Product Change Notification

Date: August 28, 2020

TCG057QVL**-***	5.7" QVGA
TCG057VGL**-***	5.7" VGA

1) Outer box size change

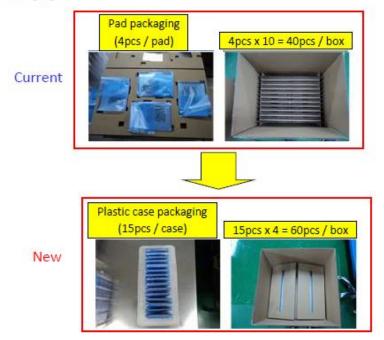
Current	New
Length x Width x Height	410 x 495 x 331	520 x 525 x 315
Outline drawing	1/0 KG	All and a state of the state of

Current : 410 x 495 x 331 (mm)

New : 520 x 525 x 315 (mm)
